INTERNATIONAL 470 CLASS

The following amendments to the Class Rules have been approved to be effective 1st March 2013 by the Class Rules Sub Committee.

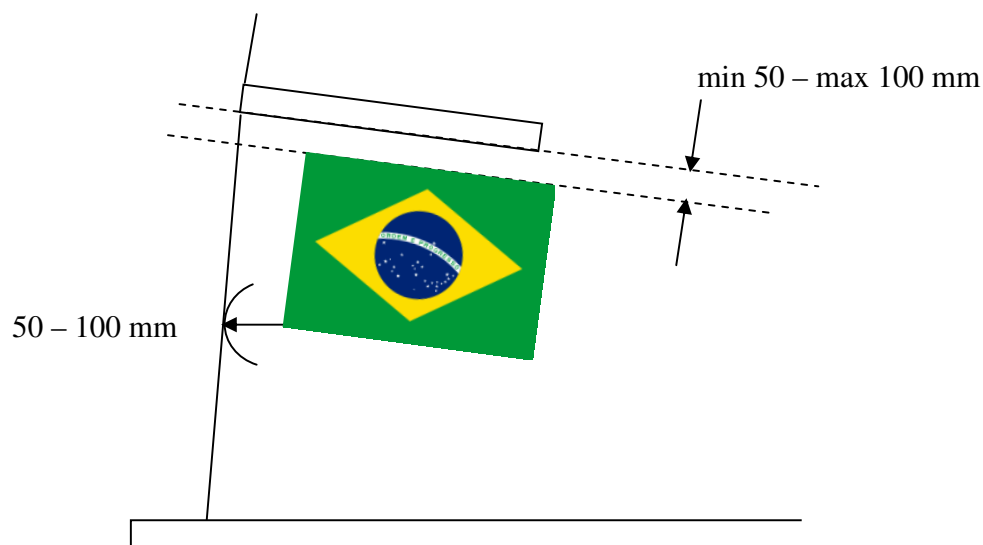
C.10.4 MAINSAIL

(a) IDENTIFICATION

(4) At the ISAF Sailing World Cup and the ISAF Sailing World Championship, or when required by a Notice of Race, a skipper's national flag, nominal size 740 x 443 mm, shall be applied to each side of the mainsail, placed as shown in the Figure "Mainsail Flag Location", so that the shortest distance of the lower aft corner of each flag is between 50 and 100 mm from the leech and the upper edge between 50 and 100 mm below the lowermost batten pocket. The flags shall be made by an ISAF approved manufacturer as listed at <http://www.sailing.org/classesandequipment/I470.php>
